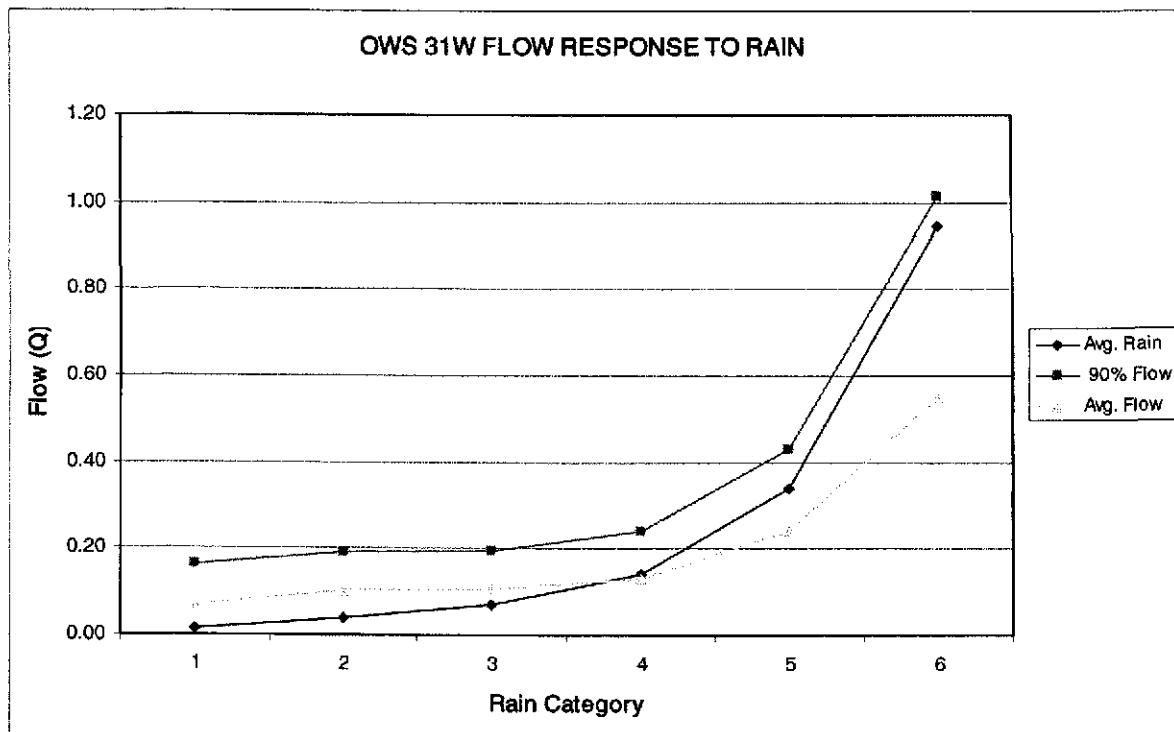
OWS 31W, which treats waters going to Outfall 001, poses unique challenges with regard to reduction of TSS. Unlike the other OWSs at the site, 31W receives municipal runoff from a large off-site drainage area (about 90 acres). The runoff from that area will contain a variety of solid materials that are not present on-site and which pose treatment difficulties for OWS 31W that are not presented for other site discharges.

Flow can be used as an indication of the potential ability for the 31W OWS to reduce influent TSS. Using Outfall 001 flow generated from 2002 to current, it is apparent that the OWS conditions during certain rain events are distinctly different from the representative OWS conditions assumed to have been the basis of the technology-based 138 lb/d. For instance, in

For specific categories of rain amounts, there is a response in average flow and 90th percentile flow when rain amounts are greater than 0.1 inch (Category 4). When rain exceeds 0.2 inches (Category 5), the 24-hr average 90th percentile flow is statistically related (*i.e.*, similar line slope) to the average rainfall. In addition, the average flow line slope also noticeably changes above Category 5. Therefore, the conclusion can be drawn that the flow through the OWS distinctly changes in response to rain events more than 0.2 inches. The 90th percentile flow for rain events greater than 0.20 inches is 0.432 mgd. The implication of this analysis is that the OWS, for a 24-hour period, will be operating in conditions distinctly different than conditions assumed to be applicable for the TSS mass limit of 138 lb/d (*i.e.*, ability to settle particles, lack of turbulent flow).

When the 24-hour average flow is above 0.432 million gallons in response to rain events, the performance of OWS 31W may not be representative of the conditions that were used to determine the monthly average mass limit of 138 lb/d TSS. Therefore, for determining compliance with the monthly average 'wet weather' TSS limit, data collected over a 24-hour period should be used if the 24-hour flow is less than or equal to 0.432 million gallons.⁷ When

the 24-hour flow is greater than 0.432 million gallons, the data and mass result should be reported but not used for compliance assessment.
